ST200 Hardware Modifications

This document concerns the **ST200 hardware delivered before July 15, 2011**.

VCO output voltage up to 10V

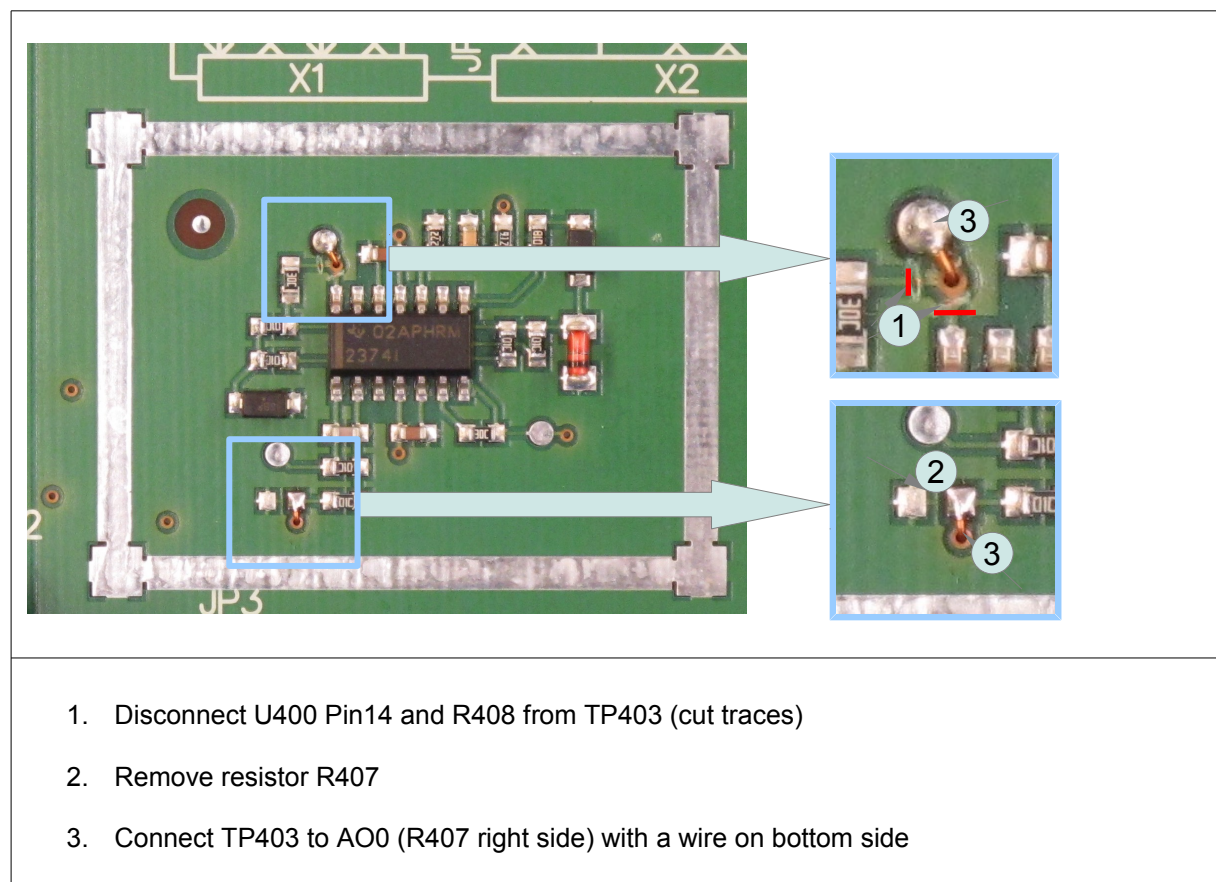
Since never versions of K-MC1, K-MC3 and K-MC4 allow a VCO input voltage up to 10V, ST200 may need hardware modifications to support this feature.

This modifications break the 5V limitation of the VCO output and allow voltages up to 10V for MC-Modules.

Enhanced -5V supply (optional)

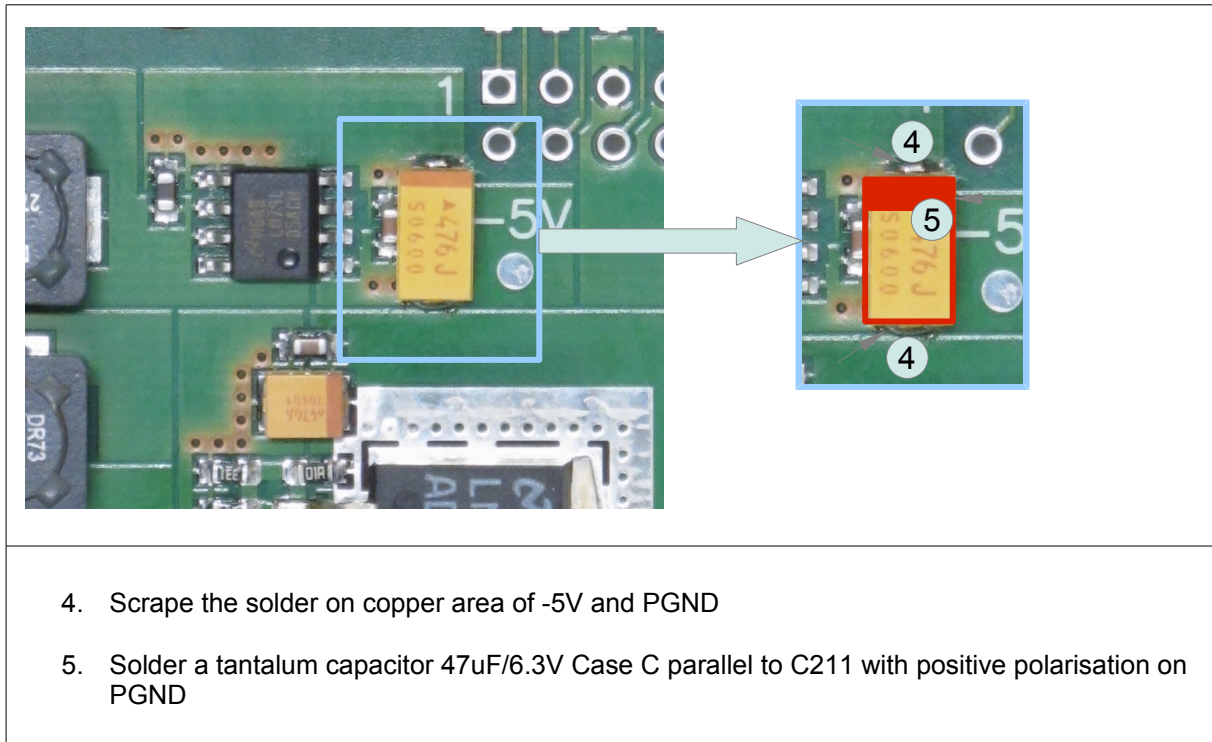
During FMCW operation, some noise may be visible in the time domain display. This can be avoided by adding the following capacitor.

The outcome of following modifications are noise reduction and more stability of the -5V supply.
